80C186XL/80C188XL EMBEDDED MICROPROCESSORS SPECIFICATION UPDATE

Release Date: January, 2002

Order Number: 272895.003

Figure 1. Correct INT1 Acknowledge Sequence with Higher Priority Timer Interrupt

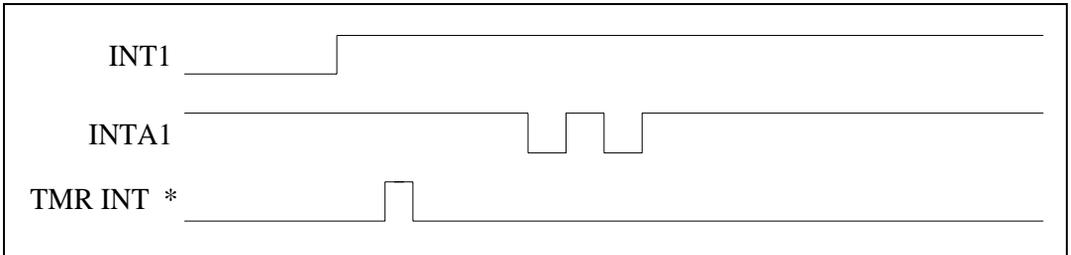
Correct operation of the device acknowledges the interrupt on INTA1# after an interrupt on INT1. Normally, this occurs even if there is a higher priority interrupt after INT1 but before the acknowledge (Figure 1).

Figure 2. Incorrect INT1 Acknowledge Sequence with Higher Priority Timer Interrupt

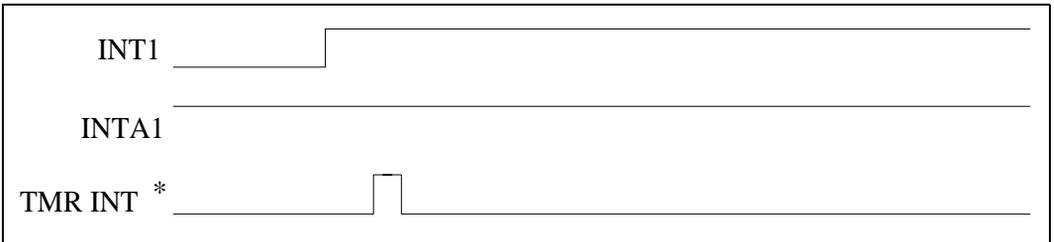
The errata occurs when a higher priority interrupt occurs between INT1 and its expected acknowledge. The processor completes internal interrupt acknowledge cycles as seen on the status lines but no acknowledge cycle is sent on the INTA1# output (Figure 2).

Figure 3. INT0 And INT1 Acknowledge Failure Due to Higher Priority Timer Interrupt

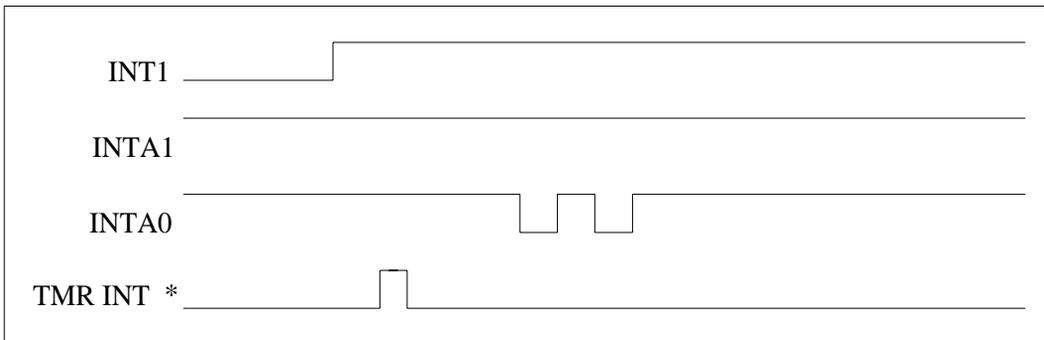
If INT0 and INT1 are configured in cascade mode and a higher priority interrupt occurs between INT1 and its expected acknowledge, then the acknowledge will appear on INTA0# instead (Figure 3).

Figure 4. Correct INT0 Acknowledge Operation with a Simultaneous INT1

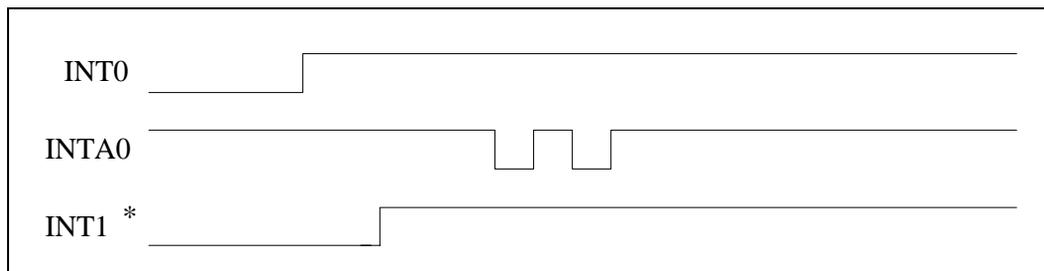
Correct operation acknowledges INT0 on INTA0#. Normally, this occurs even if there is a higher priority INT1 after INT0 but before the acknowledge (Figure 4).

Figure 5. Incorrect INT0 Acknowledge Operation with a Simultaneous INT1

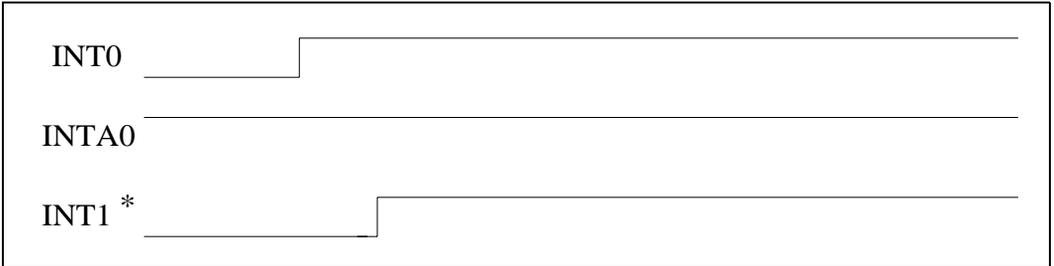
The errata occurs when INT1, which is higher priority than INT0, occurs between INT0 and its expected acknowledge. The processor completes internal interrupt acknowledge cycles as seen on the status lines but no acknowledge cycle is sent on the INTA0# output (Figure 5).

Figure 6. INT0 and INT1 Acknowledge Failure Due to the Higher Priority INT1

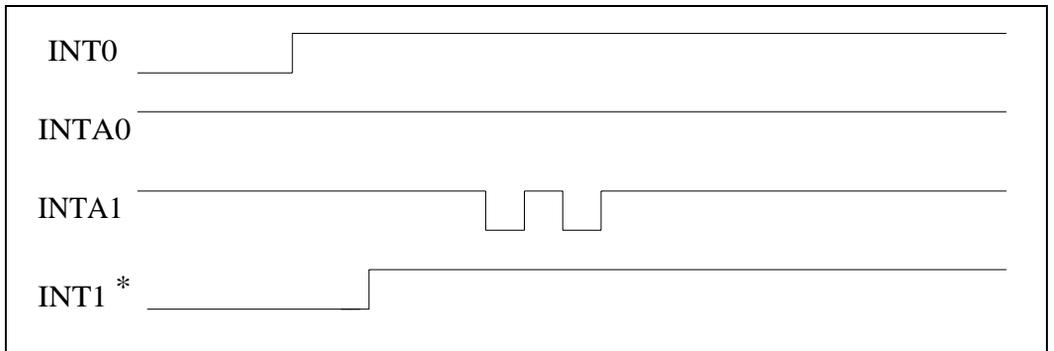
If INT0 and INT1 are configured in cascade mode and the higher priority INT1 occurs between INT0 and its expected acknowledge, then the acknowledge will appear on INTA1# instead of INTA0# (Figure 6).
